**Re: City of Nampa Pressure Zone 1 Creation
Recommendation of Notice to Award**

CITY OF NAMPA, IDAHO
PRESSURE ZONE 1 CREATION
PROJECT NO. PWWA200031

ADDENDUM NO. 1
to the
CONTRACT DOCUMENTS & SPECIFICATIONS, and DRAWINGS
for the
Pressure Zone 1 Creation
City of Nampa, Idaho

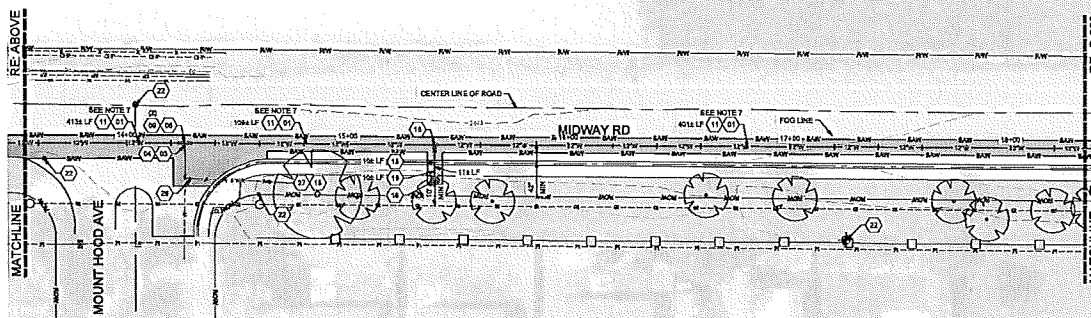
- Replace Sheet C-301 with the updated Sheet C-301 attached to this addendum.
 - Changes include: A general note has been added at the end of the existing 12-inch waterline at station 10+00 for the contractor to remove a blow off if it is found during the work.

1. *What is the approximate start date for the project?*
 - a. *The City anticipates getting Council approval to move forward with the project on 7/15/2024. It is anticipated that the project will be able to start at the end of July.*
2. *City records show a blow off at the end of the existing 12-inch waterline at station 10+00 on Midway Rd but it was not located.*
 - a. *A general sheet note will be added to sheet C-301 to remove the blow off if found. If it is found, removal of the blow off will be incidental to the work.*
